WCAP-16793-NP, Rev.0 (Non-Proprietary)
Project No. 694

March 2, 2009

OG-09-84

Subject: Pressurized Water Reactor Owners Group
Responses to the NRC Request for Additional Information (RAI) on WCAP-16793-NP, "Evaluation of Long-Term Cooling Considering Particulate, Fibrous and Chemical Debris in the Recirculating Fluid" (PA-SEE-0312)

Figure 1 Comparison of Reactor Vessel Metal Temperature at Bottom of Fuel; Outside Diameter versus Inside Diameter

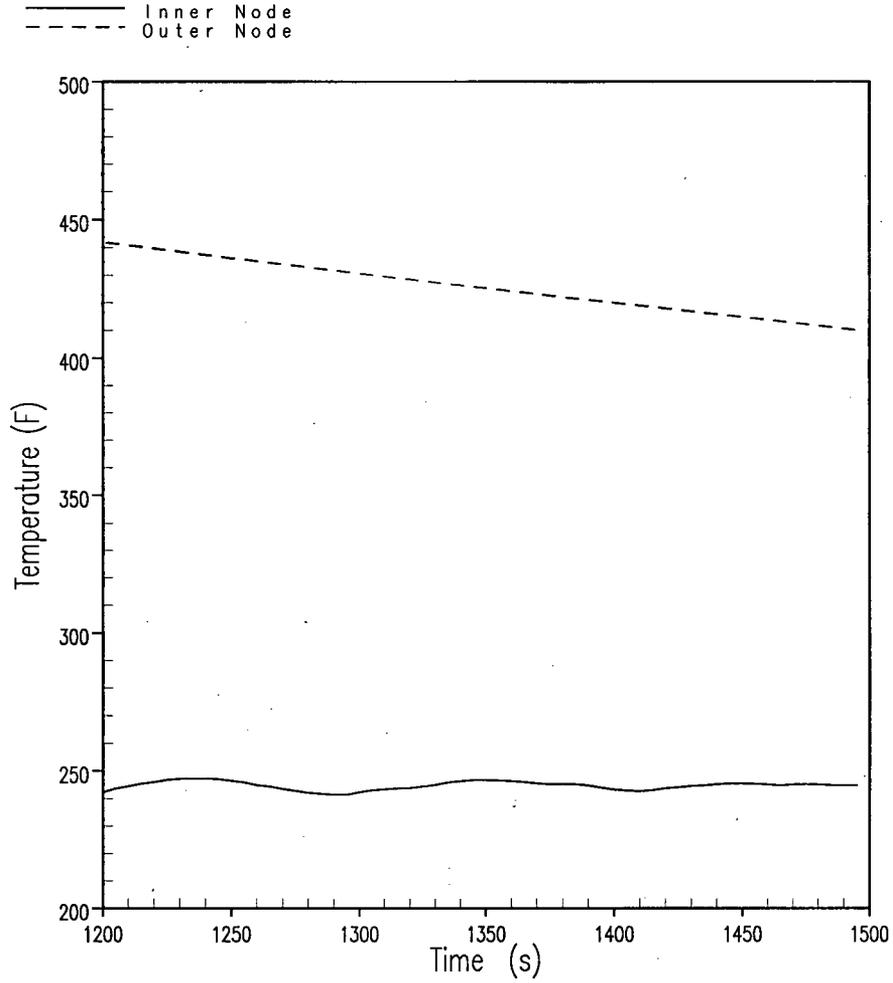
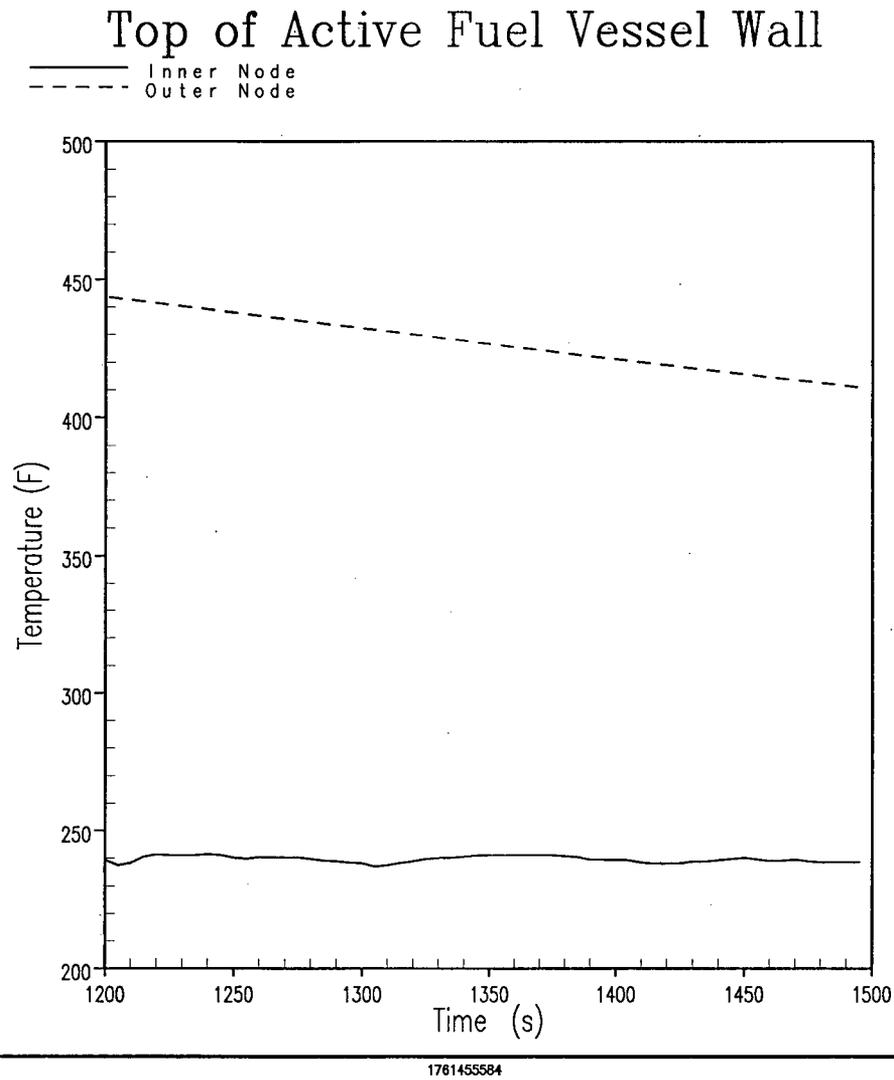
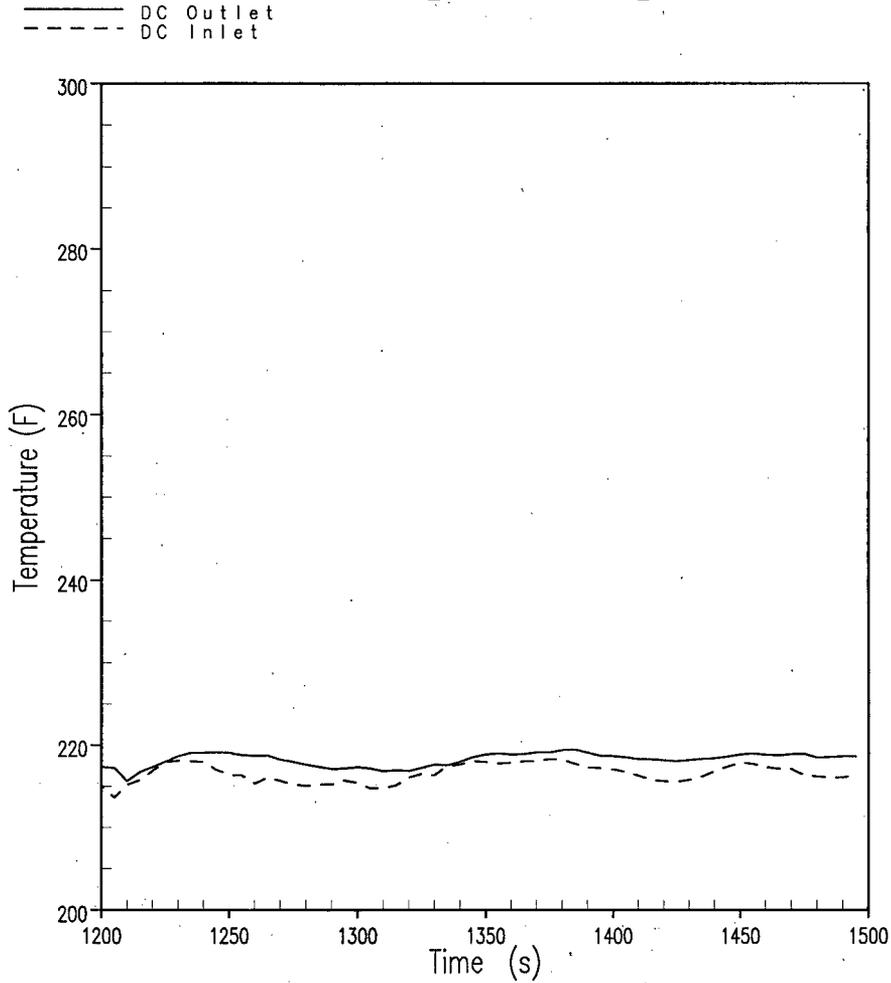
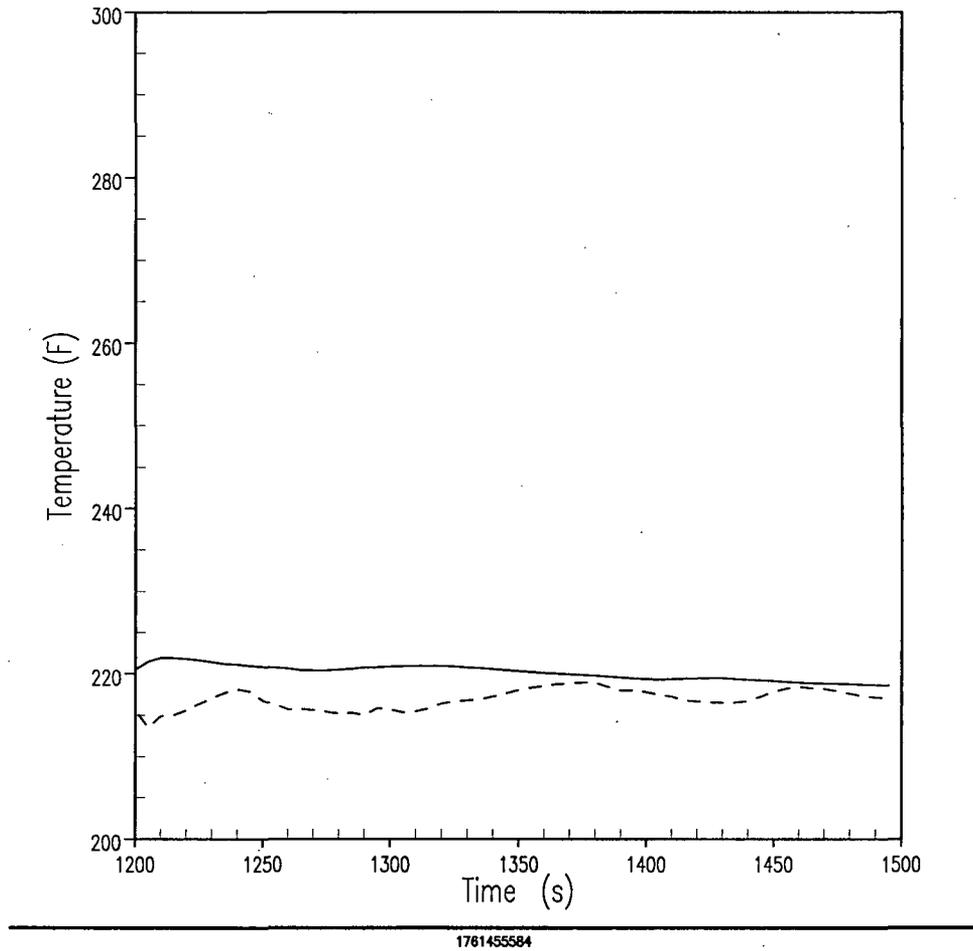
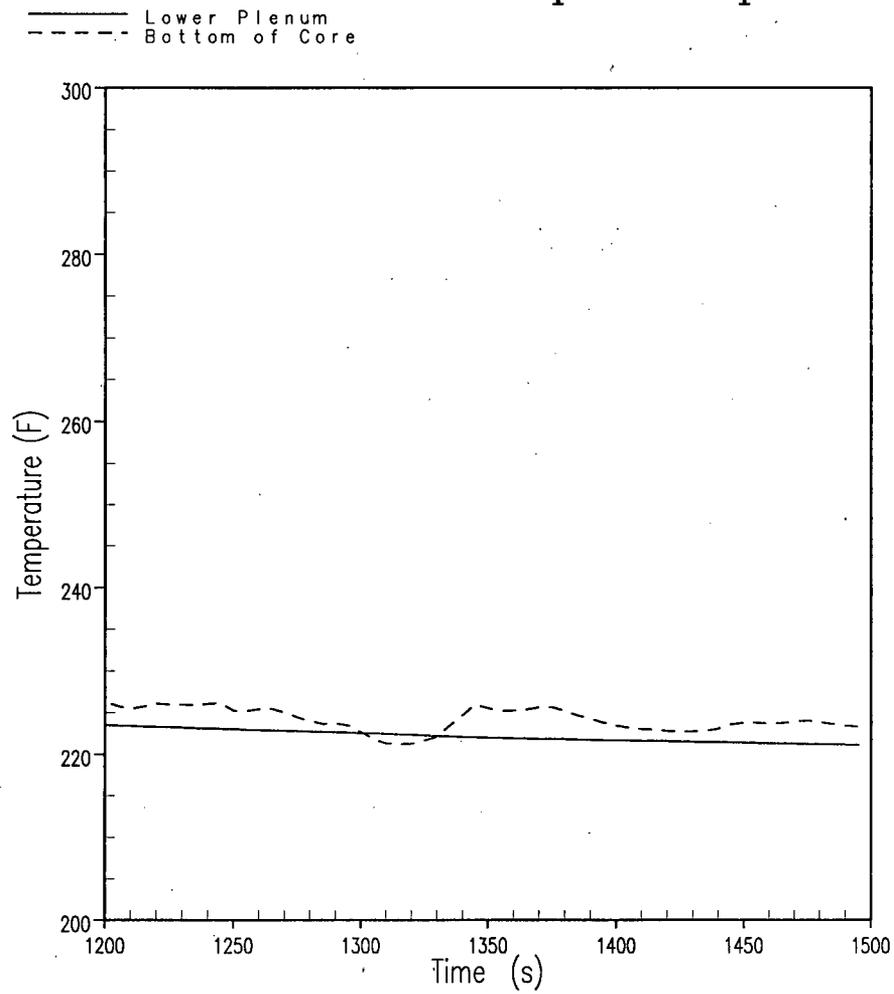
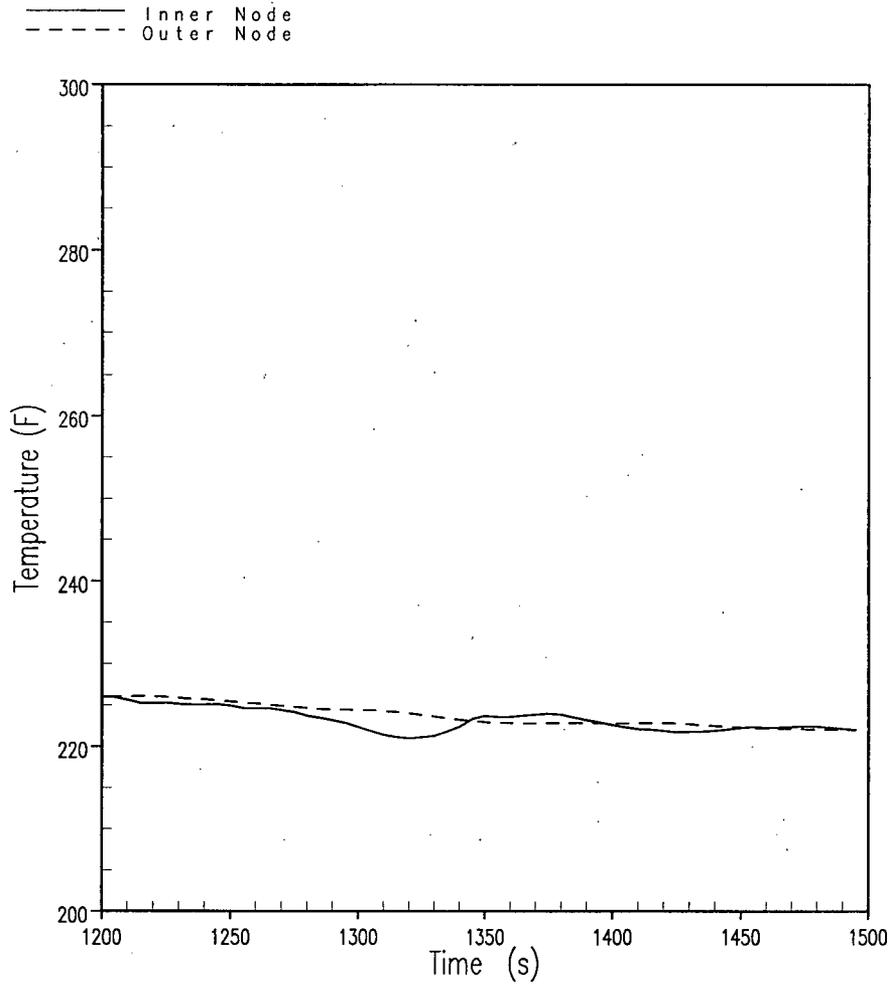
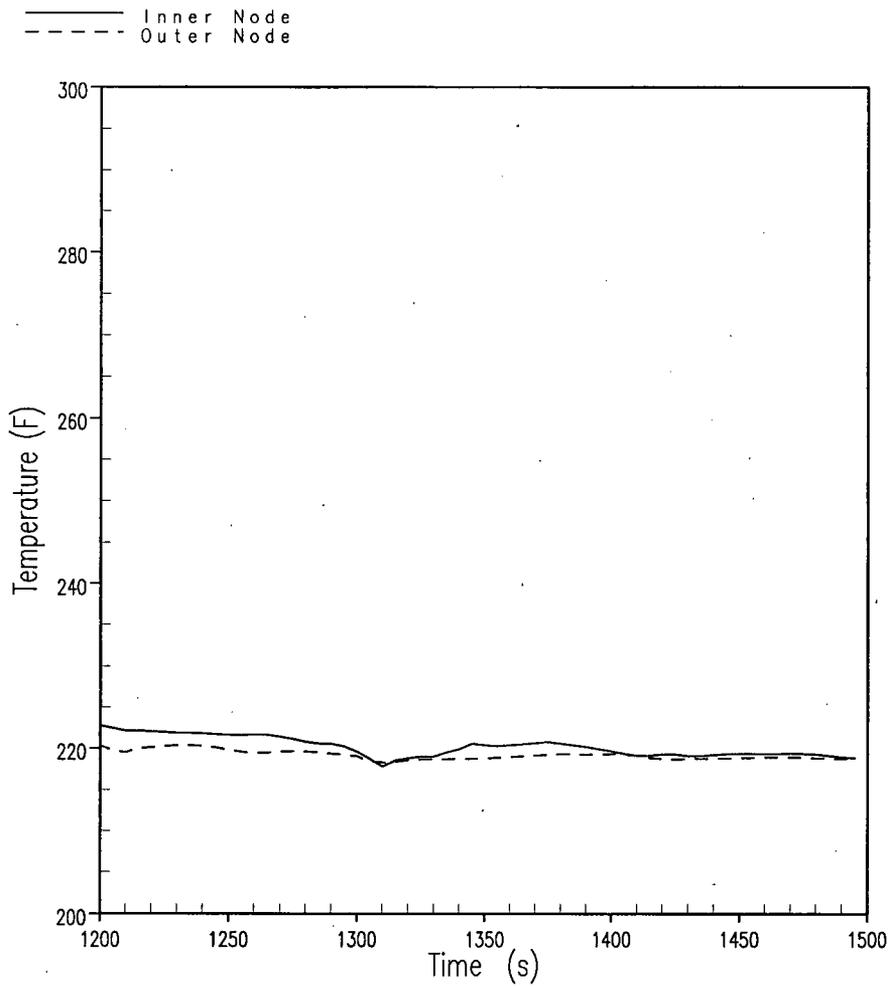
- 8) Following a LOCA, thermal energy stored in the thick reactor vessel shell and the reactor vessel baffle/barrel can influence the coolant temperature at the core inlet. For both a hot leg break and a cold leg break, please provide an estimate of the core inlet temperature as a function of time, starting at the onset of ECCS recirculation and ending when an equilibrium reactor vessel metal temperature has been reached. Please discuss how this temperature would affect:
- the solubility of aluminum-based precipitates,
 - the solubility of calcium-based precipitates and,
 - the potential for chemical precipitates to form in the vessel as a result of these phenomena.

Figure 1, Comparison of Reactor Vessel Metal Temperature at Bottom of Fuel; Outside Diameter versus Inside Diameter, and Figure 2, Comparison of Reactor Vessel Metal Temperature at Top of Fuel; Outside Diameter versus Inside Diameter, are time history plots of the temperature of the inner and outer RV metal nodes of the WCOBRA/TRAC calculations for a postulated cold-leg break. From Figures 1 and 2, it is noted that the temperature of the inner RV metal node at the top and bottom of the core is relatively unchanged over the 300 seconds following switchover from BWST/RWS injection to recirculation from the reactor containment building sump. Over this same time period, the outer RV node is predicted to drop by about 30°F. These figures demonstrate that the heat transfer process is conduction limited.

Figure 3, Comparison of Fluid Temperature at Top and Bottom of Downcomer, shows that there no more than about 5°F temperature gain in the coolant as it passes from the top to the bottom of the downcomer. Likewise, Figure 4, Comparison of Fluid Temperature at Top and Bottom of Baffle, shows a similar behavior. It is noted that the initial 10°F temperature difference diminishes to about a 5°F temperature difference within about 150 seconds of switchover from BWST/RWST injection to recirculation from the reactor containment building sump. Figure 5, Comparison of Fluid Temperature in Lower Plenum to Core Inlet, shows that the coolant at the core entrance is calculated to be generally slightly warmer but within about 5°F of the coolant in the RV lower plenum. Figures 6 and 7, Comparison of Fluid Temperature Between Core Inlet and Inside Baffle, and Comparison of Fluid Temperature Between Core Outlet and Inside Baffle, respectively, shows the calculated fluid temperatures at the core inlet and core outlet to be within less than about 5°F of each other throughout the calculation time period. More importantly, over
